BABCOCK ROAD 165
 AMENDED
 MASTER DEVELOPMENT PLAN (MDP)

June 20, 2007

Re: Babcock Road 165 (Amendment)

MDP # 827-A

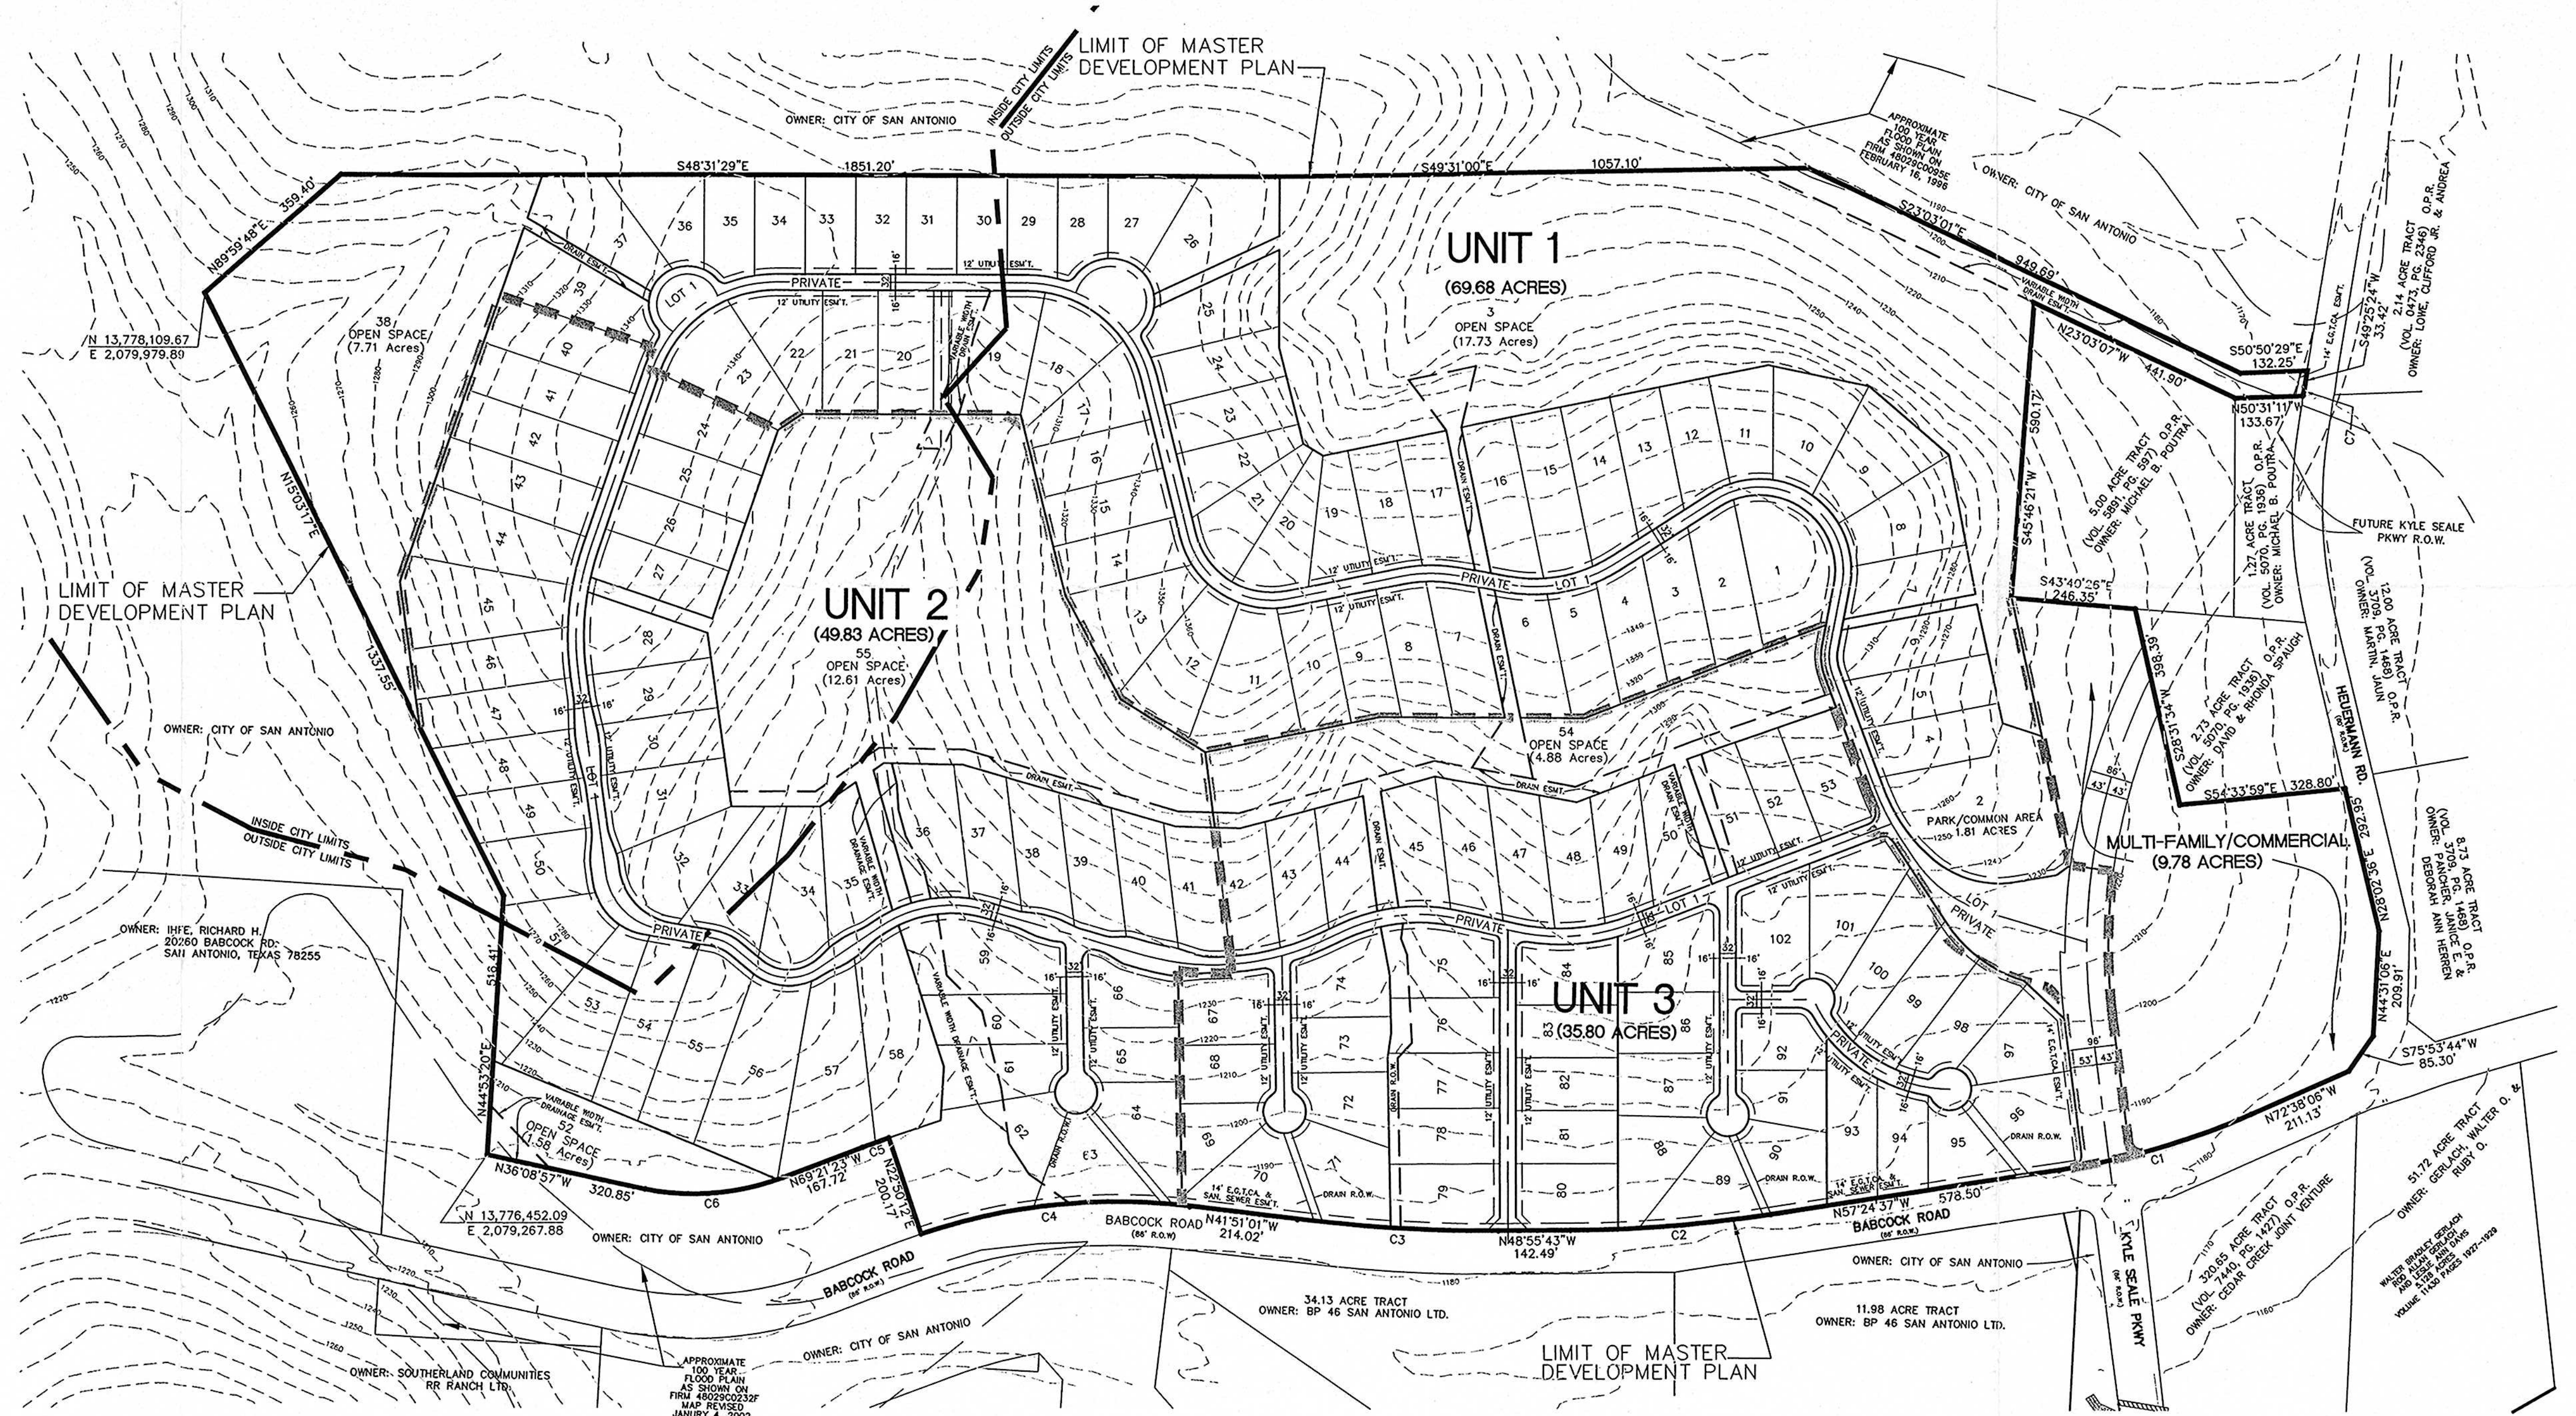
In consideration of public safety and convenience, excessive grades by reason of topography should be avoided in street layouts and arrangements. Any access and right-of-way issues along state facilities will need to be resolved with the **Texas Department of Transportation (TxDOT)**. For information about these requirements you can contact TxDOT at (210) 615-5814.

1. Dedicate and construct Kyle Seale Parkway as a secondary arterial type "A" four lane divided roadway, within the limits of this MDP.
2. Provide a minimum of 100-foot queue storage for the residential entrance from Kyle Seale.
3. A median opening on Kyle Seale Parkway will be allowed 480 feet east of Babcock for the residential access. However, if traffic demand for the westbound Kyle Seale Parkway creates queuing problems in the future due to the proximity of residential entrance to Babcock, the median opening may be closed.
4. The developer shall coordinate with Jim Brannan, P.E. (210-335-6711) at Bexar County for the extension of Kyle Seale Parkway due to a current Capital Improvement Project on Babcock Road .

It is understood that this MDP is a conceptual plan and controlled access should be maintained in order to uphold safe and efficient traffic flow. Therefore, the developer of this property is encouraged to design common access and shared driveways between all proposed commercial or multi-family lots. Bexar County reserves the right to address driveways, street design, sight distance, ADA requirements, drainage, and floodplain issues at time of platting.
